March 26, 2019

Ms. Jennifer Armer
Community Development Department
Town of Los Gatos
110 E. Main Street
Los Gatos, CA 95031

RE: 15925 Quail Hill Road

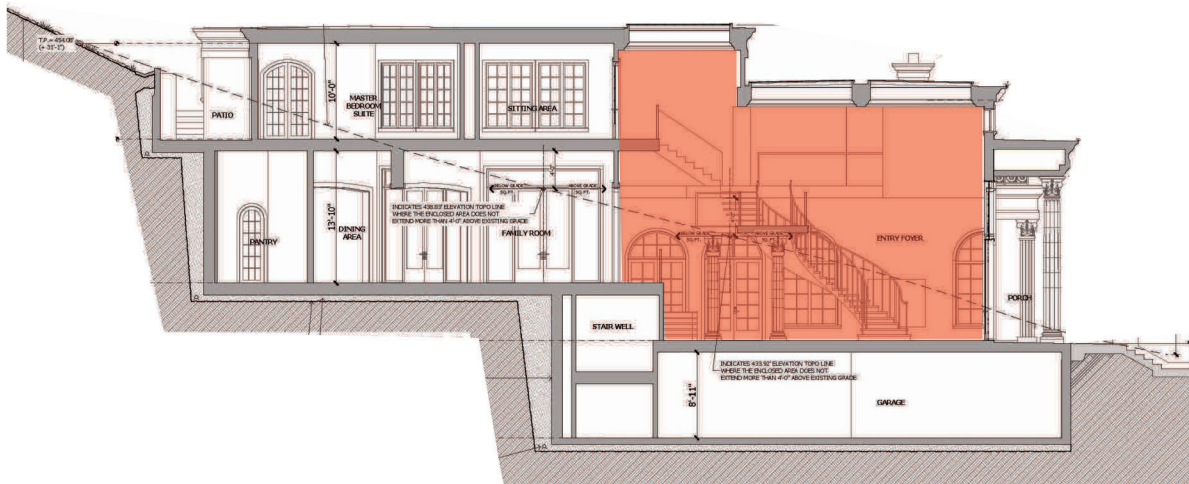
1. The general building form reads as three boxes stacked on top of each other.

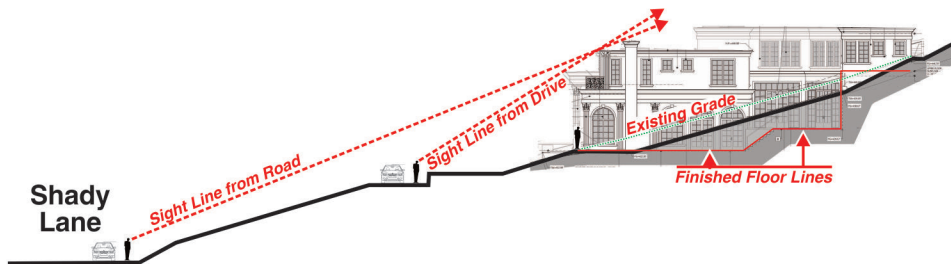
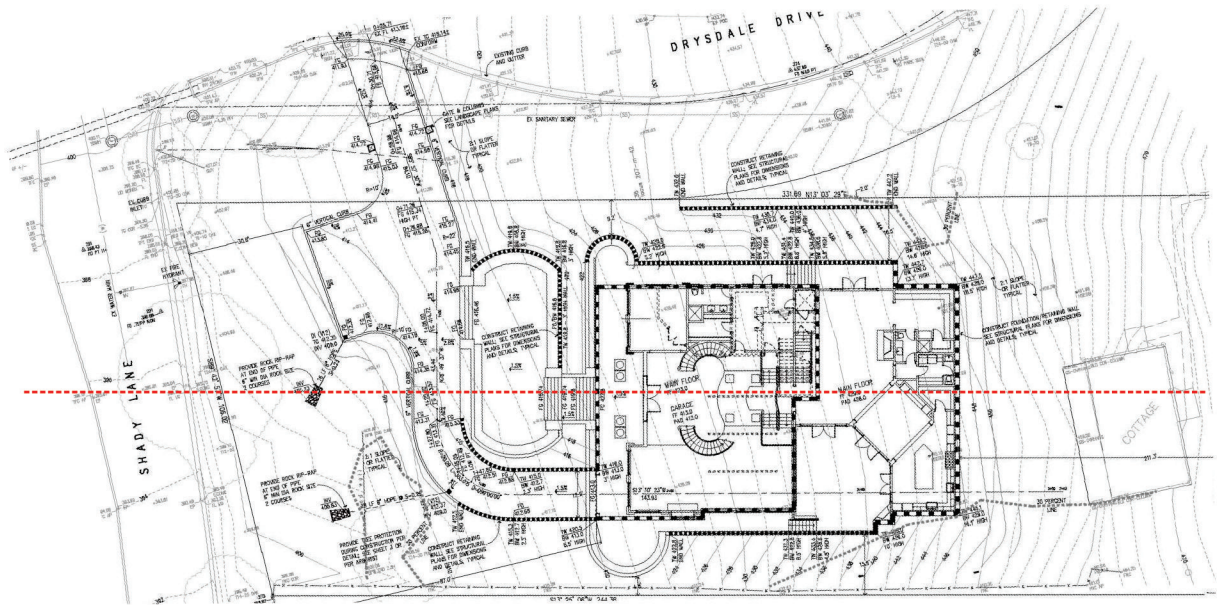
2. The grand scale of the front portion of the house which would be 25 feet in interior height would increase the structure's visual bulk.

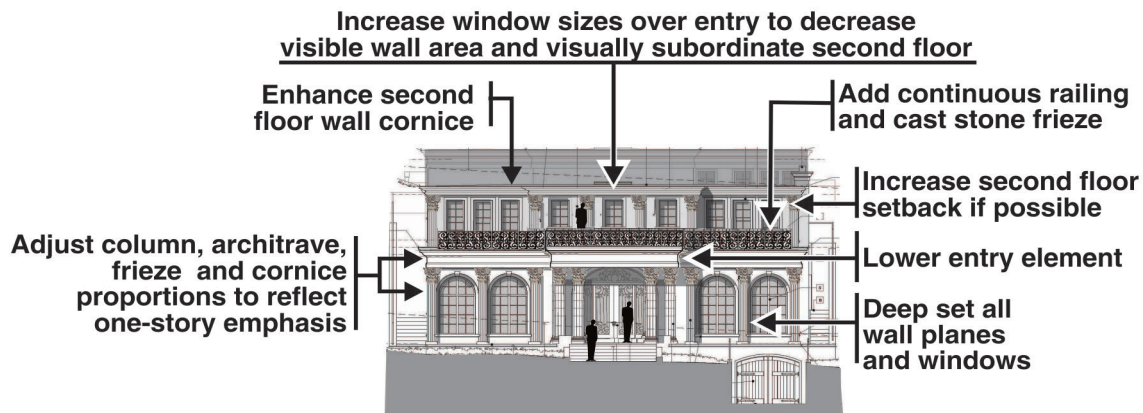
3. While there is a slight setback from the front facade for the second floor volume, it is likely not enough to avoid the first and second floor facades appearing as a single large volume. This would be further emphasized by the tall entry element and the elevated building pad relative to Shady Lane - see illustration below.

CURRENT PROPOSED FRONT ELEVATION

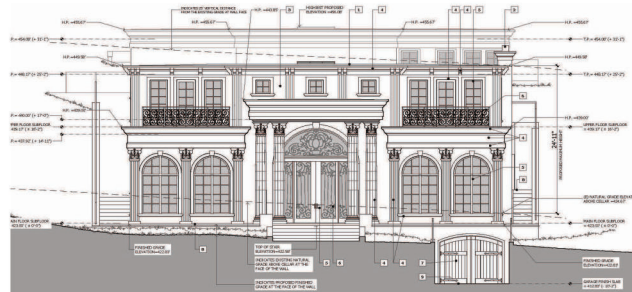
The formal style of the proposed home makes modifications to more strictly conform to the standards and guidelines difficult without resulting in a distortion of the basic forms and details of the traditional style. There are a few modifications that I can suggest that would maintain the spirit of the architectural style. They would include the following:

1. Increase the second floor setback, if possible.
2. Add continuous railings and cast stone friezes in lieu of the currently proposed three separated front elevation forms.
3. Increase the window sizes on the second floor over the entry.
4. Enhance the second floor cornice to add more visual substance.
5. Deep set all wall planes and windows.
6. Add additional landscape buffering along the street edge.
